FINAL DRAINAGE REPORT

FALCON RANCHETTES FILING NO. 1A
MERIDIAN STORAGE
El Paso County, Colorado

PCD File No. VR239 & PPR2336

DETENTION BASIN OUTLET STRUCTURE DESIGN

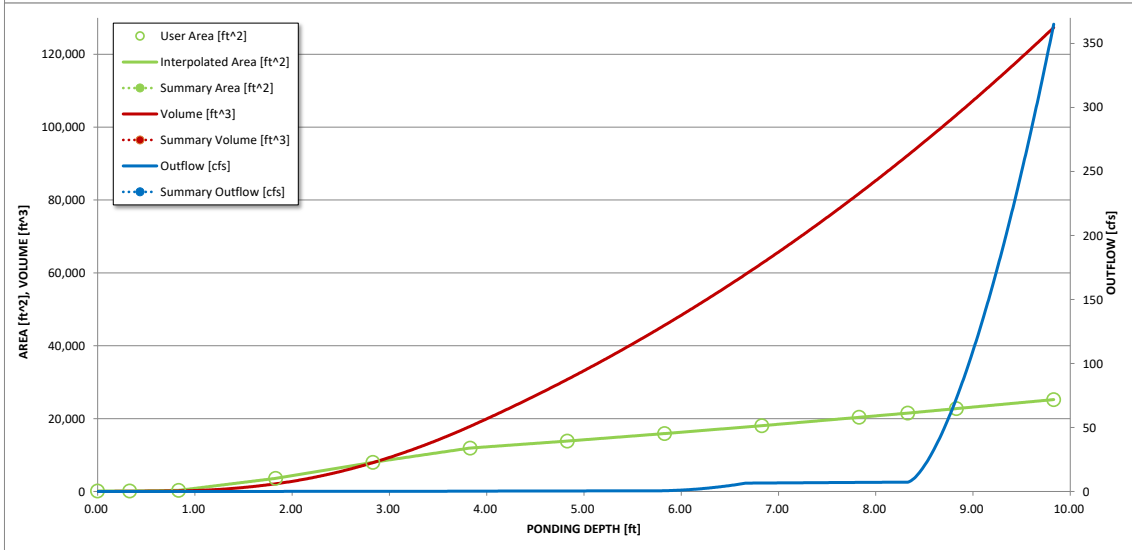
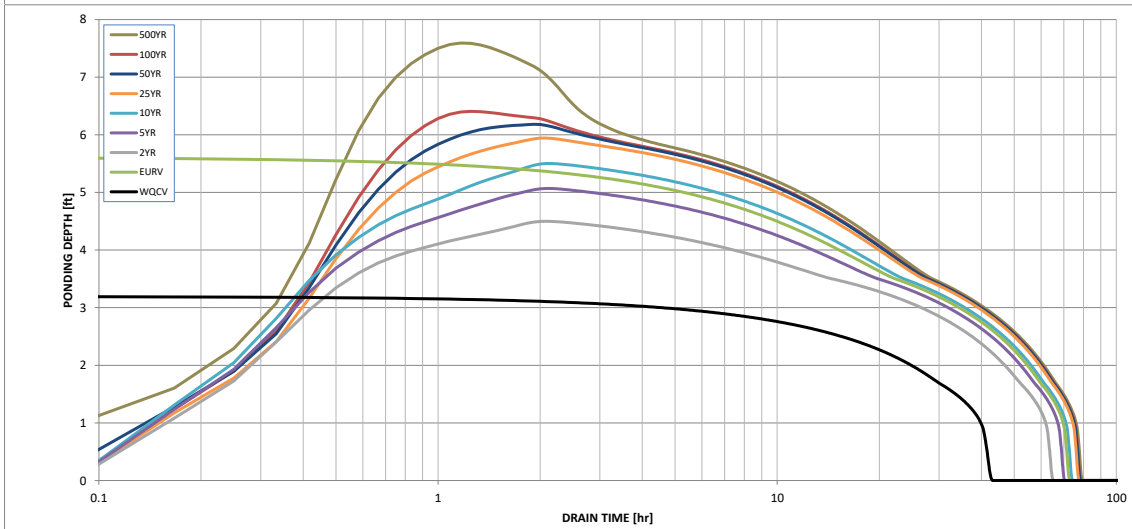
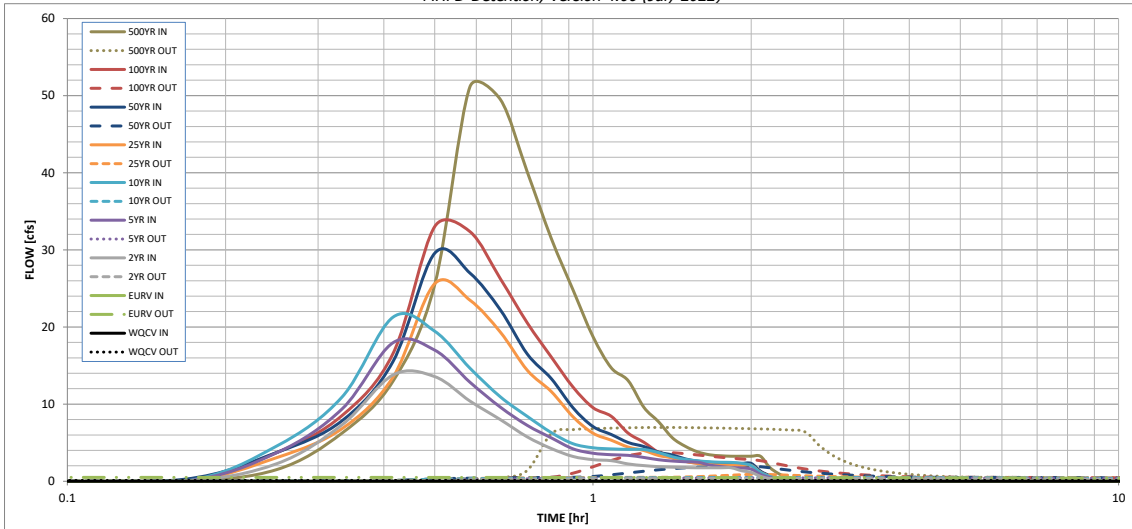
Verify and update so the ratios are not above 1

MATCHLINE - SEE SHEET DR-3

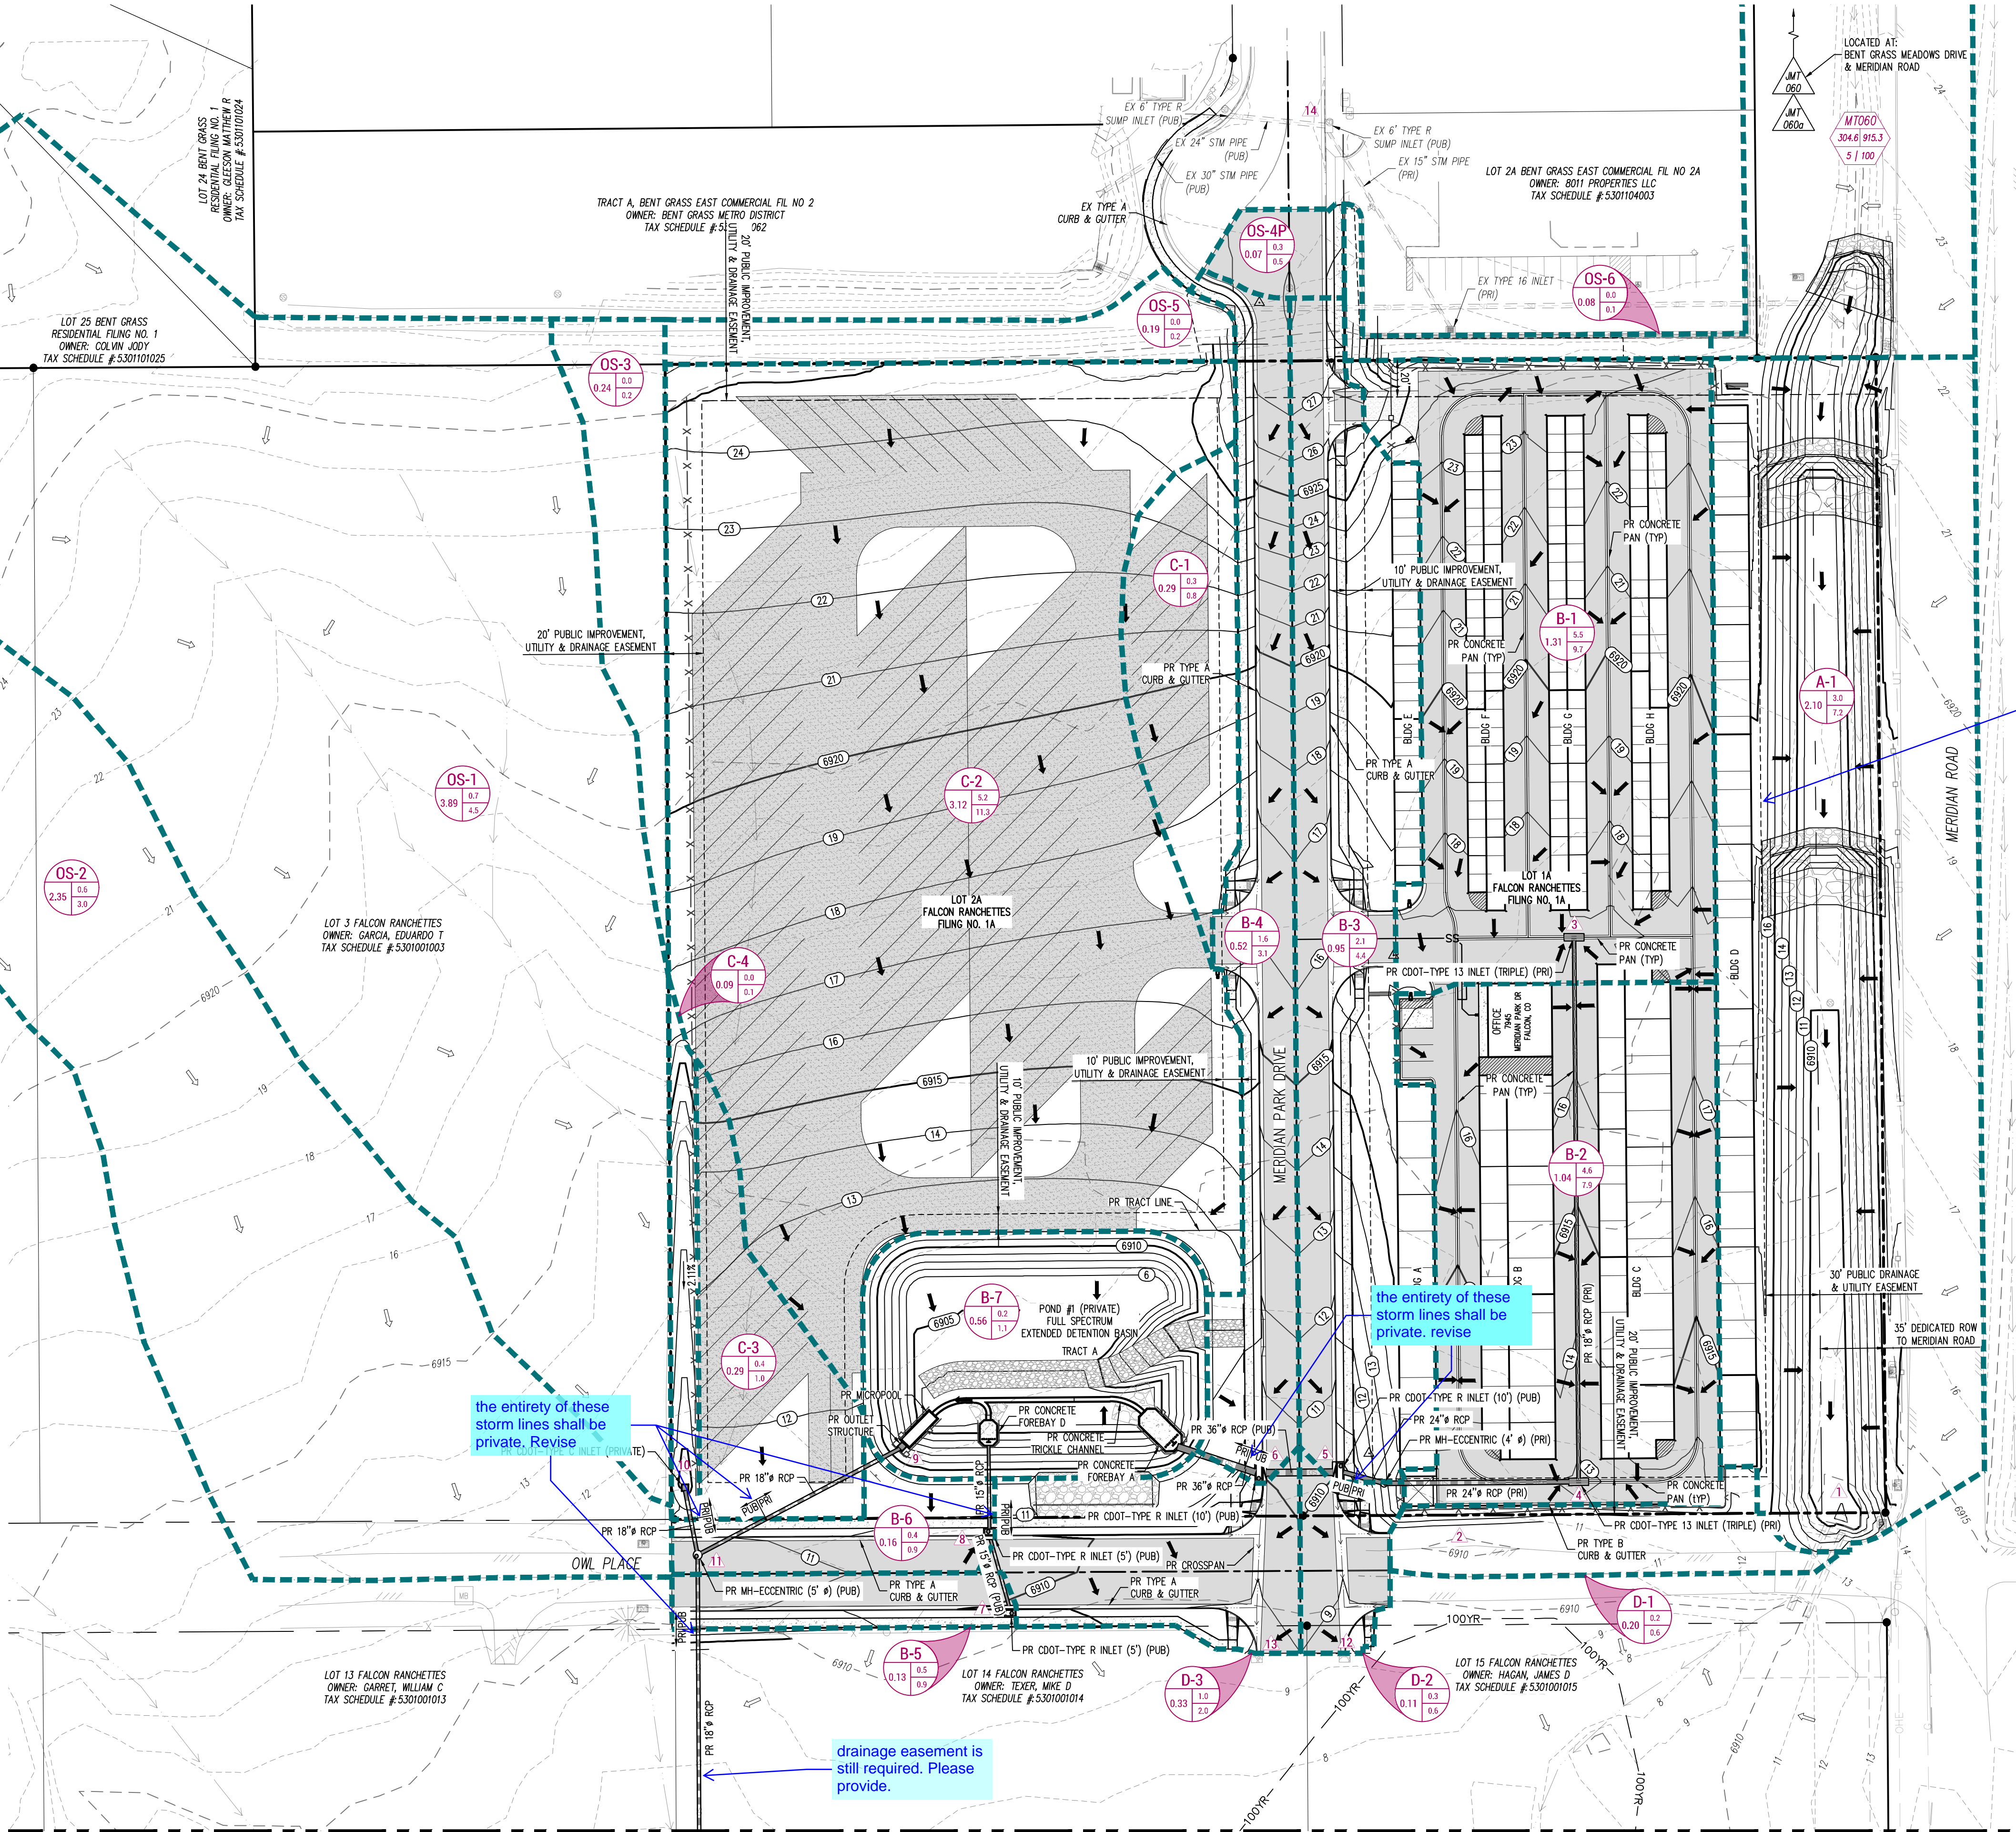
please provide/indicate the intended easement and maintenance access for the channel. (see ECM 3.3.3.K.1)
